## ADDENDUM 1

To the Contract Documents for the New Parking Lot

Grand Terrace Elementary School  
Colton Joint Unified School District  
SGH Architects Project Number: 22-12105-04  
DSA A#04-122929

**C-3.2**

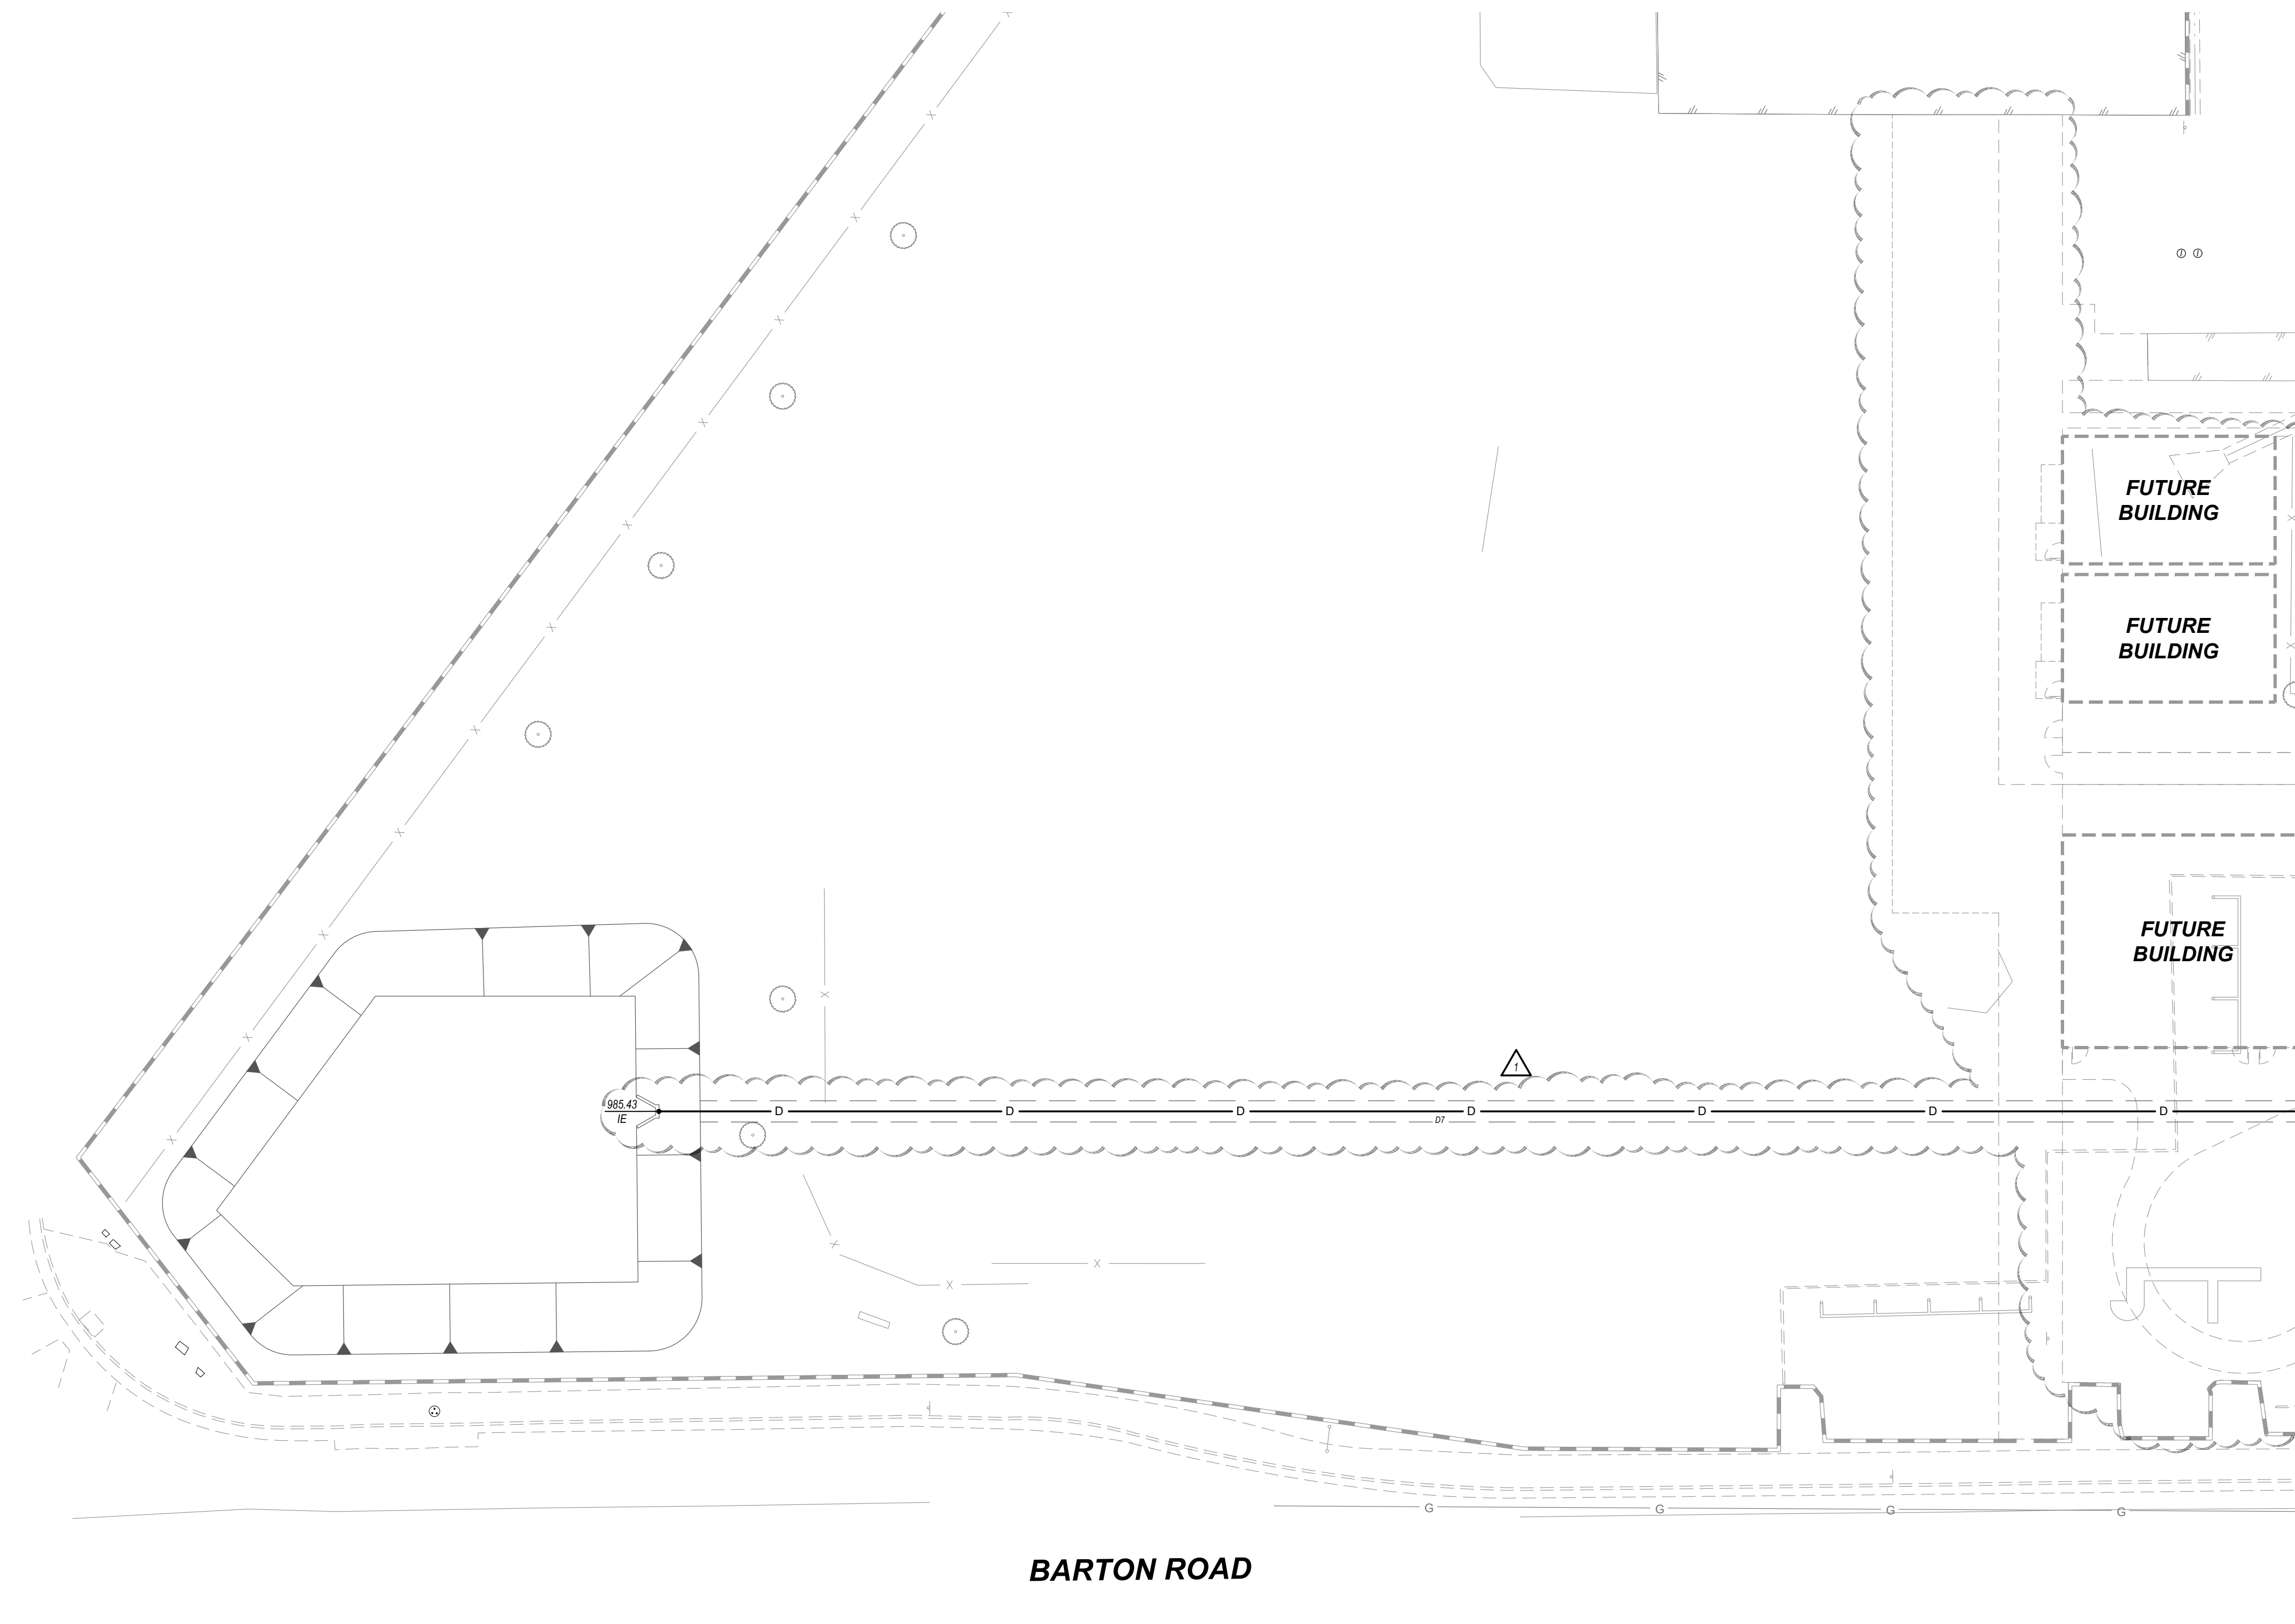
- E. Sheet C-3.2 – Precise Grading Plan  
(Attachment 9)
  - a. Relocated manhole to avoid conflicts with existing tree.
  - b. Revised limits of grading to match new storm drain layout.
  - c. Revised sawcut scope to match new storm drain layout.
  - d. Addition of future improvements in the background for reference.
  - e. Addition of several protect in place/adjust to existing grade notes to several existing items.
  - f. Provided new graded swale and planter drain North of parking lot.
  - g. Showing existing posts that are to be protected in place.

**C-5.2**

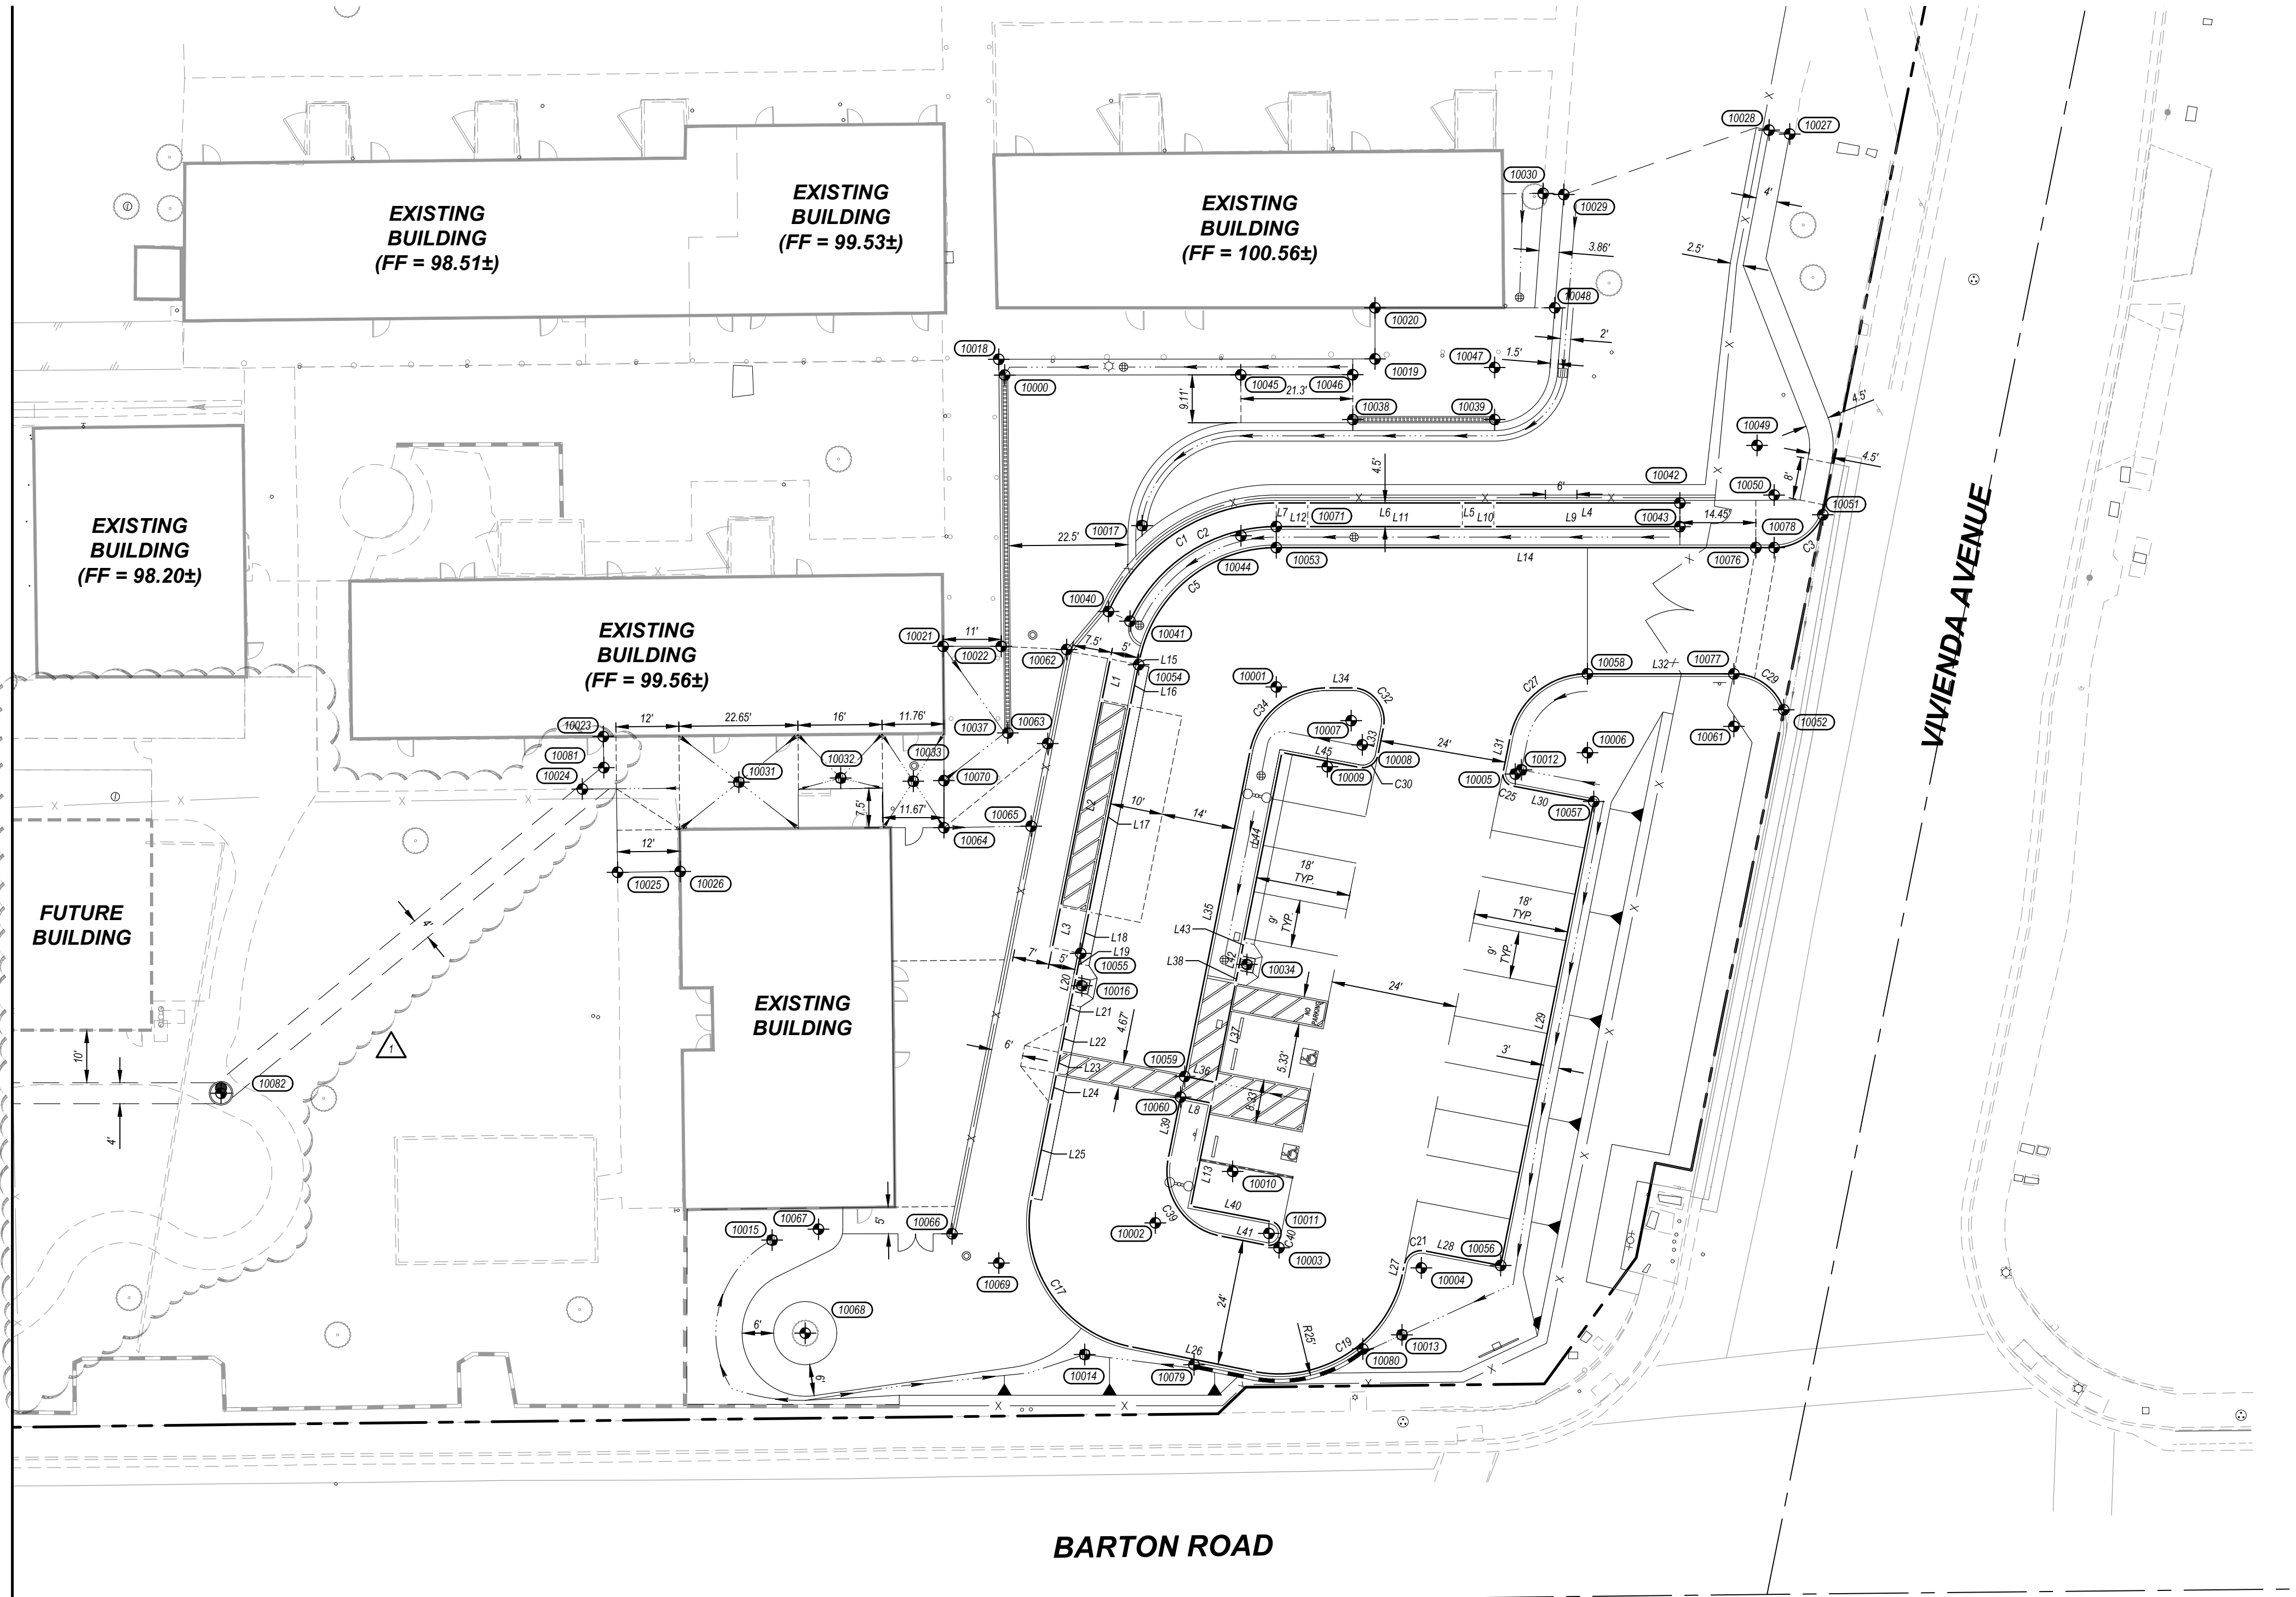
- b. Revised Horizontal Control Table data.
  - c. Addition of future improvements in the background for reference.
- I. Sheet C-5.2 – Horizontal Control Plan  
(Attachment 13)

- a. Adjusted dimensions for limits of grading.
  - b. Revised Horizontal Control Table data.
  - c. Relocated various sawcut control points to match new site plan changes.
